Access Compliance Report

Public Rights-of-Way

(Curb Ramps)

Intersection ID: 22250	Main Street: SHARON_LAKES_RD	Cross Street: SOUTH_BV	Location: SE
ADA ID: B753AD433391	Ramp Type: Perp	Initial Pass/Fail: Fail	Overall Compliance: No
Severity Score: 22.5			
Codes/Mitigation Info/Possible Solution		Field Measurements/Component Compliance

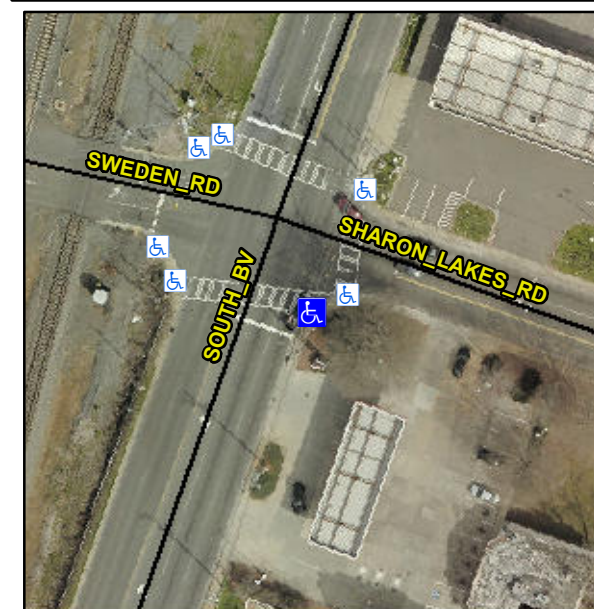
Not Found, R304.5.1, R304.2.2, R304.5.3

Compliance	Description	Data	Compliance	Description	Data
N/A	Ramp Length (in)	58.0	No	Ramp Slope (%)	11.7
No	Ramp Width (in)	45.0	No	Ramp XSlope (%)	3.8
N/A	Flare Type LT	N/A	N/A	Flare Type RT	N/A
N/A	Flare Slope LT (%)	N/A	N/A	Flare Slope RT (%)	N/A
N/A	Flare Traversable LT?	N/A	N/A	Flare Traversable RT?	N/A
N/A	Landing Length (in)	N/A	N/A	DWS Provided?	N/A
N/A	Landing Width (in)	N/A	N/A	DWS Contrast?	N/A
N/A	Landing Slope (%)	N/A	N/A	DWS Length (in)	N/A
N/A	Landing X Slope (%)	N/A	N/A	DWS Full Width?	N/A
N/A	Landing Curb? (Y/N)	N/A	N/A	DWS Offset (in)	N/A
N/A	Shared Landing?	N/A			
N/A	Gutter Ponding?	N/A	N/A	Gutter Slope (%)	N/A
N/A	Gutter Lip Ht (in)	N/A	N/A	Gutter X Slope (%)	N/A
N/A	Painted X Walk1?	Yes	N/A	Painted X Walk2?	N/A
	X Walk 1 Direction	To W		X Walk 2 Direction	N/A
N/A	X Walk 1 Width (in)	122.0	N/A	X Walk 2 Width (in)	N/A
	X Walk 1 Slope (%)	2.8		X Walk 2 Slope (%)	N/A
	X Walk 1 X Slope (%)	0.1		X Walk 2 X Slope (%)	N/A

Remove & Replace Entire Ramp.
